HARNESS KIT 63412
DODGE DAKOTA/DURANGO
2001 & LATER

DAKOTA WIRING CHANGE FOR MODEL YEAR 2001 VEHICLES

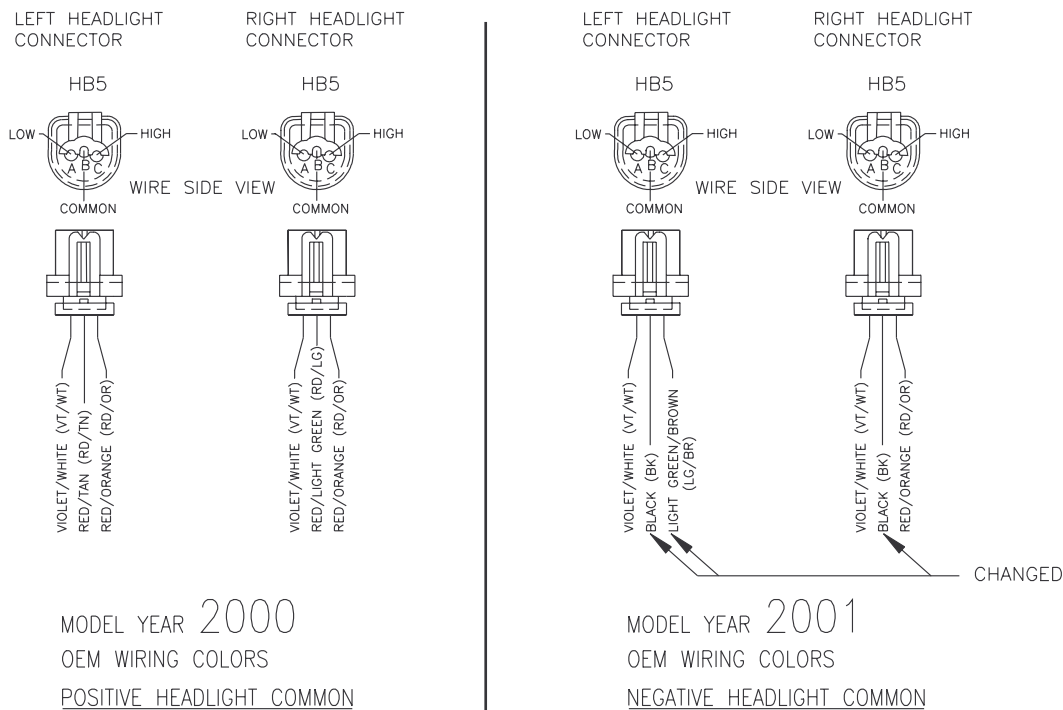
This kit is for use on 2001 Dakota/Durango vehicles that have a central timer module. These vehicles can be identified by checking the center wire on the headlamp connector:

2001 vehicles have a BLACK wire in the middle position on both sides of the vehicle.

1999/2000 vehicles have a RED/TAN or a RED/LIGHT GREEN wire and should use the 63396 kit on vehicles without DRL's or 63404 with DRL's.

Follow the instructions in the mount box for installing the headlamp plug-in harness. Make the connections to the four headlamp relays as shown in the diagram included with this kit. Revision 3 and later plug-in harness 63413 has a dark blue wire terminated with a fully insulated blade (male) that is not used in this installation.
